## County of Fairfax, Virginia

**STAFF REPORT**

**PCA 76-M-007-02**

**PROPOSAL:** Amend the proffers associated with RZ 76-M-007 to permit an addition to an existing school for a gymnasium; an outdoor play area; a school bus drop-off and pick-up loop; and associated sidewalks and crosswalks.

## GENERALIZED DEVELOPMENT PLAN

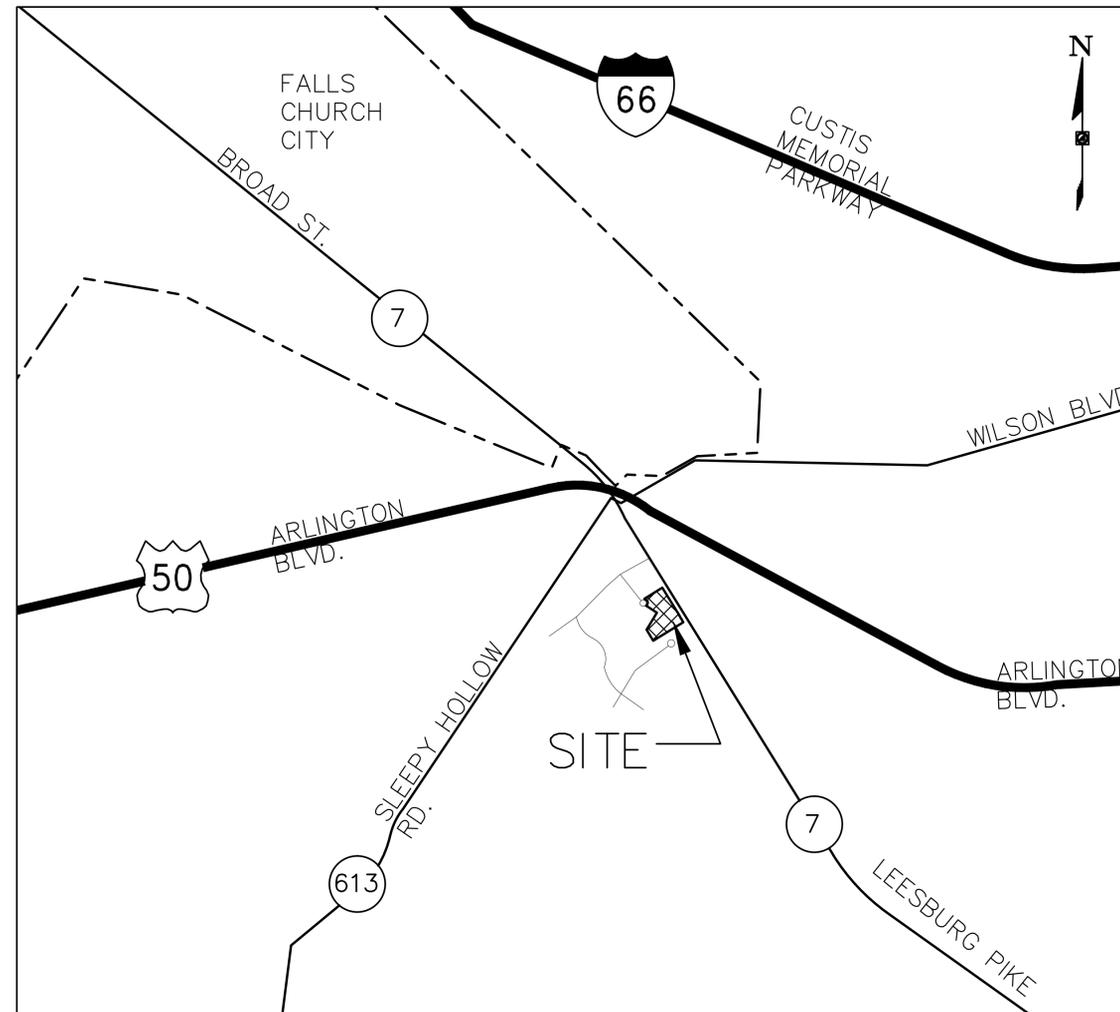
- Depict and label a potential future interparcel connection between the school property and commercial property adjacent to the southeastern boundary. This would ensure that the school site maintains access to a stop light on Leesburg Pike in the event that the service drive is eliminated due to added transit lanes along the corridor. The Seven Corners Transportation Plan indicates a need to provide a connection. Furthermore, the proposed Comprehensive Plan Amendment for the Seven Corners Community Business Center (CBC) recommends future interparcel connectivity between the school and the adjacent property;

southeastern boundary (see sheet 3). This would ensure that the school site maintains access to a stop light on Leesburg Pike in the event that the service drive is eliminated due to added transit lanes along the corridor. The Seven Corners Transportation Plan indicates a need to provide a connection; furthermore, the proposed Comprehensive Plan Amendment for Seven Corners Community Business Center (CBC) released on April 3, 2015 recommends future interparcel connectivity between the school and the adjacent property.

Additionally, staff is working with the applicant to clarify the proffers regarding the provision of a possible interparcel connection to the southeast without the need for a PCA, in the event that the Leesburg Pike frontage is reconfigured and the southern access closed, and complete crosswalks in the adjacent right-of-way across the two entrances. The applicant has provided color renderings of the Details Sheet. Finally, the applicant noted that they would work with the appropriate County and State agencies regarding a reconfiguration of the Leesburg Pike frontage and changes to their access points as necessary in the future.

**ORNAMENTAL IRON FENCE**

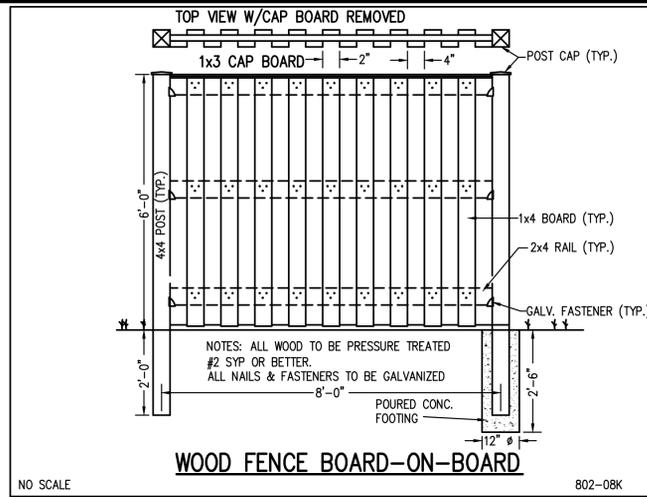
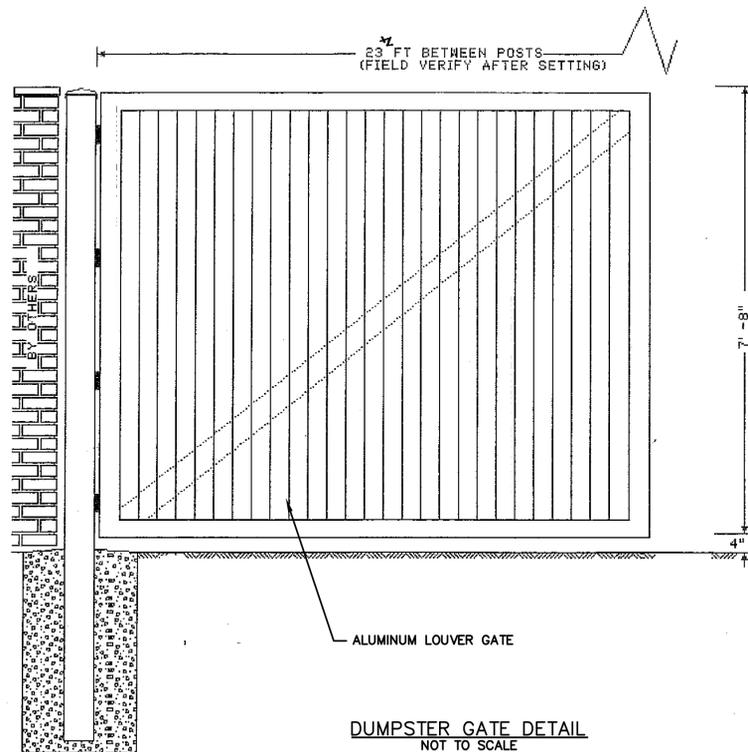
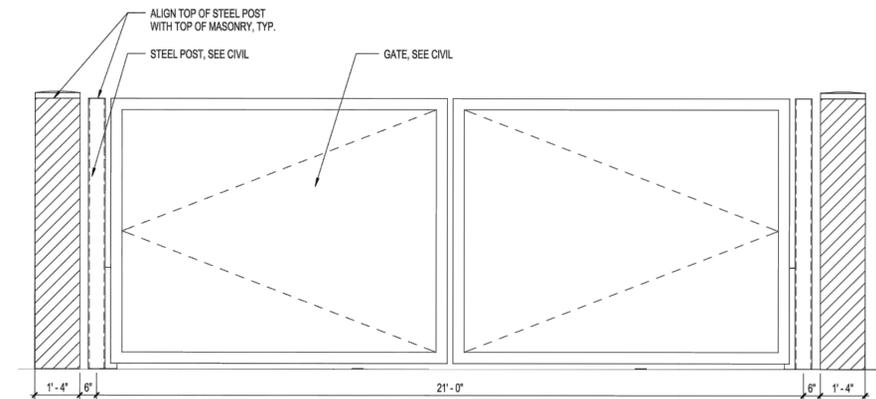
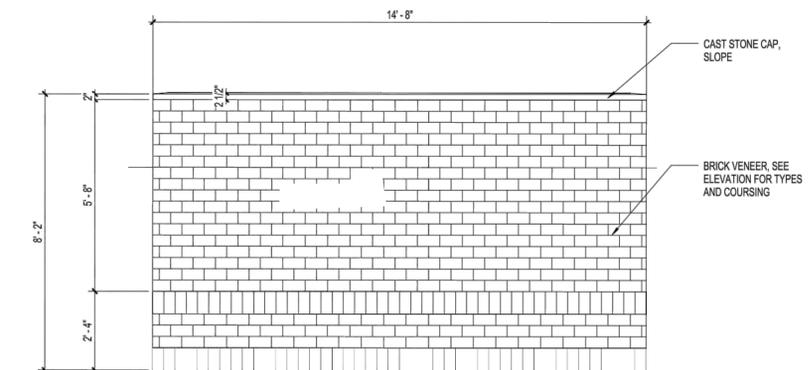
- Provide a color rendering that depicts the design, materials, and general color palette of items within the Details sheet and include any new proposed ornamental iron fencing on the Details Sheet and verify it will match the existing ornamental iron fencing on the site; and

4. The applicant should provide, for review, a color rendering that depicts the design, materials, and general color palette of items within the Details sheet. The applicant should provide further details beyond “Brick Veneer,” “Aluminum Louver Gate” and “Cast Stone Cap” to assist with understanding of the proposal (see sheet 3A). The applicant should also include any new proposed ornamental iron fencing on the Details sheet and verify it will match the existing ornamental iron fencing on the site.
5. In general, the existing streetscape along Leesburg Pike does not comply with the future Leesburg Pike Streetscape Urban Design concept and streetscape design guidelines outlined in the Comprehensive Plan.
6. The applicant should consider striping pedestrian crosswalks along the south (Kiss and Ride) entrance and north (bus) entrance to enhance pedestrian circulation, awareness and safety.

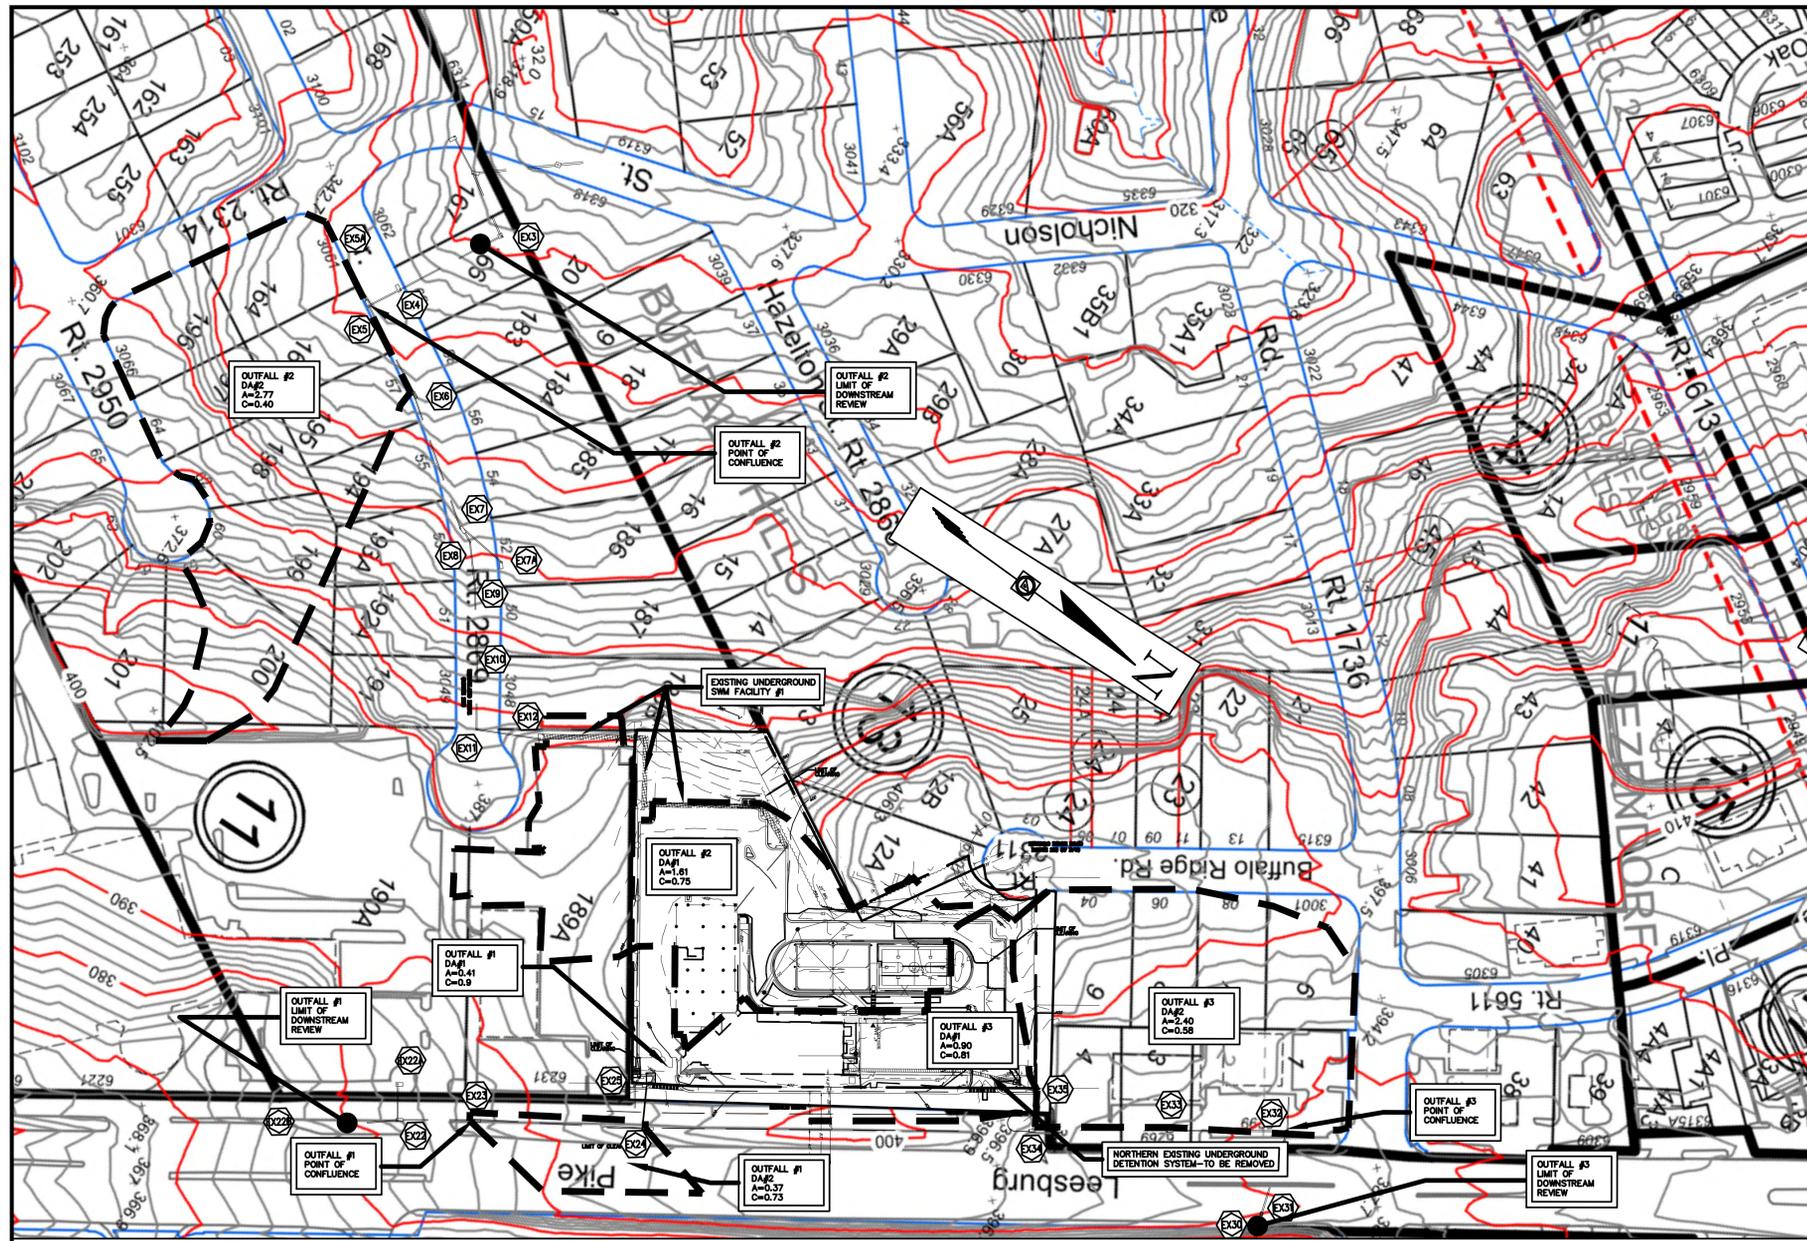
The applicant should add the computations on the PCA plan Sheet#7 and BMP requirements should be satisfied using Occoquan method computations.

**1 EAST ELEVATION - LEESBURG PIKE**  
 A401 SCALE: 1" = 10'-0"

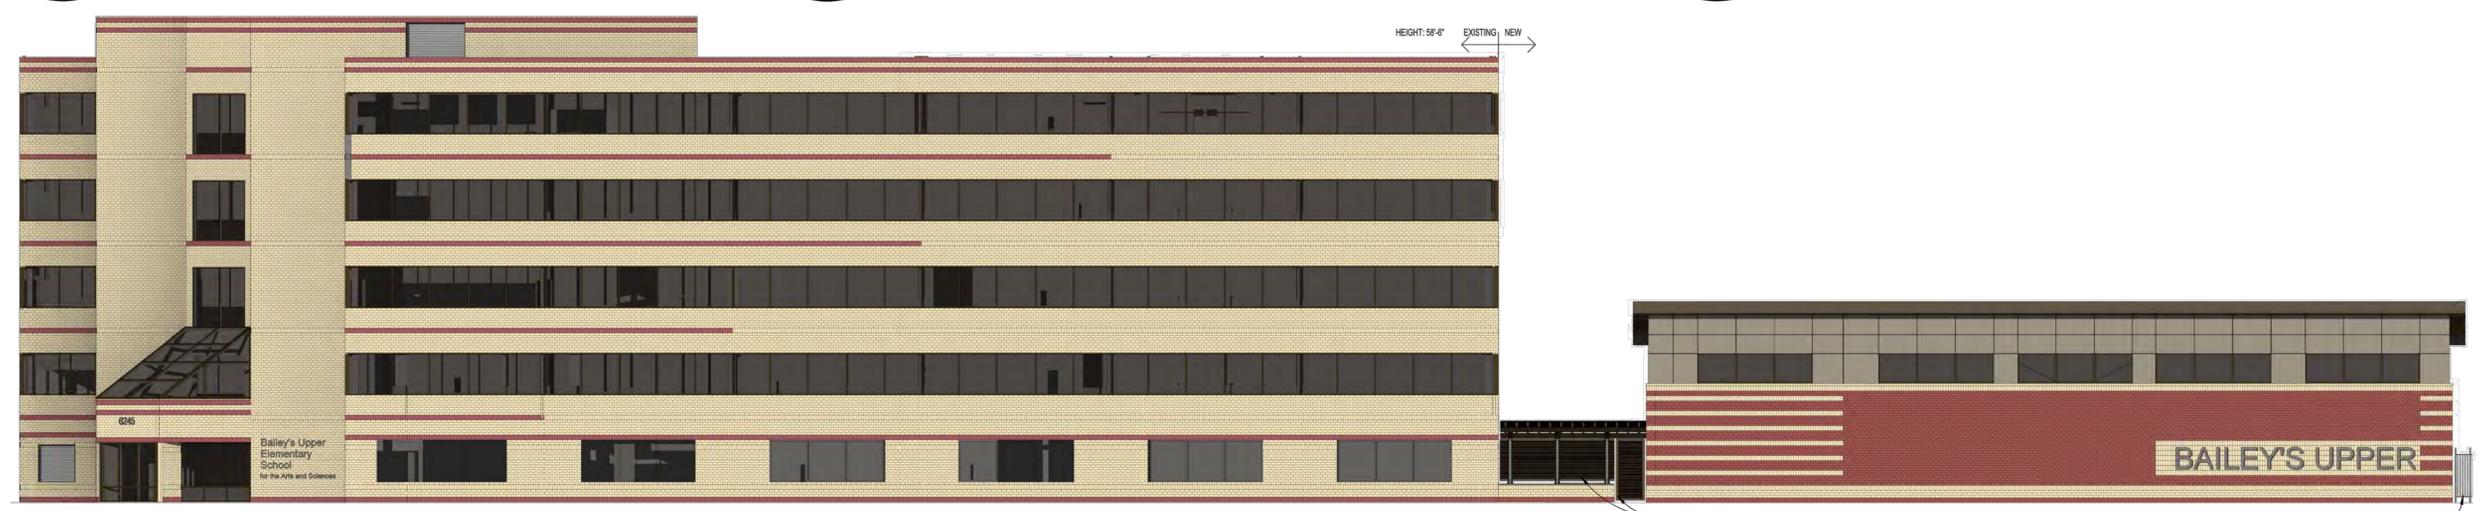
- Provide further details on the gymnasium building materials and finishes and clarify whether the brick types being proposed for the gymnasium will match or blend with the brick used in the existing school building;

- Consider moving the bottom edge of the gymnasium windows and metal paneling lower in order to match the bottom edge of the existing building's second floor window line and provide window line symmetry between the two buildings;

1. The applicant should provide further details on the gymnasium building materials and finishes beyond "Brick 1," "Brick 2" and "Metal Panel" to assist with understanding of the proposal (see sheet 9). The applicant should also clarify if the brick types being proposed for the gymnasium will exactly match, or blend, with the brick used in the existing school building.
2. The applicant should consider moving the bottom edge of the gymnasium windows and metal paneling lower in order to match the bottom edge of the existing building's second floor window line (see sheet 9). This slight alteration will provide window line symmetry between the two buildings.
3. The applicant should depict and label on the GDP a potential future interparcel connection between the school property and commercial property immediately adjacent to the

In response to staff recommendations, the applicant has committed to bricks and mortar that will match those of the existing building to the extent feasible. In regards to the windows, the applicant noted that the top half of the proposed windows already match the top edge of the existing second floor windows. However, larger windows would be required in the gymnasium if the bottom edge of the windows were also to match, and would result in increased costs and possible conflicts with the gymnasium activities.
